Access Compliance Report

Public Rights-of-Way

Intersection ID: 44026	Main Street: MT_HOLLY-HUNTERSVILLE_RD	Cross Street: COULOAK_DR	Location: NE
ADA ID: CE4D7C5F3128	Ramp Type: BlendTrans1	Initial Pass/Fail: Pass	Overall Compliance: No
Severity Score: 0			
Codes/Mitigation Info/Possible Solution		Field Measurements/Component Compliance

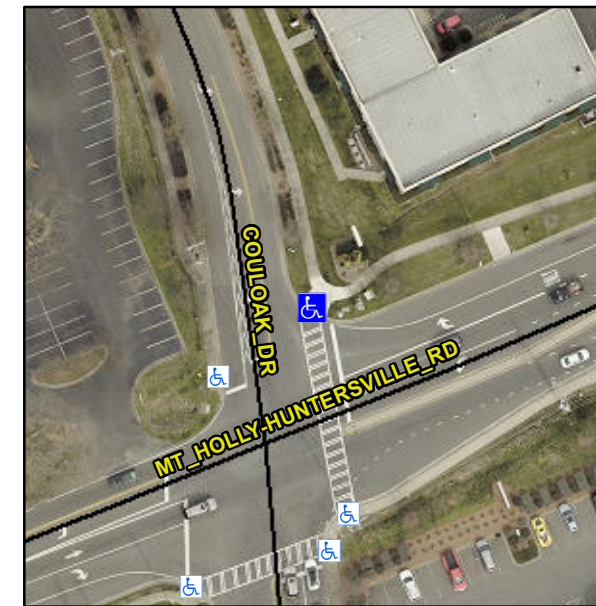
Not Found, R305.2

N/A	Ramp inside XWalk1?	N/A	Yes	Ramp inside XWalk2?	Yes
	Road Slope (%)	0.5		Clear Space?	Yes
	Road X Slope (%)	3.7	N/A	Clear Space to XWalk (in)	N/A
Yes	Any Obstructions?	No	Yes	Storm Grate/Utility Hazard?	No
	Obstruction Type			Storm Grate/Utility Type	
		N/A			N/A
			Yes	Surface Condition? (G/P)	Good
			No	Curb Slope (%)	5.3

Remove & Replace Curb Ramp With Two New Directional Ramps or Equivalent.
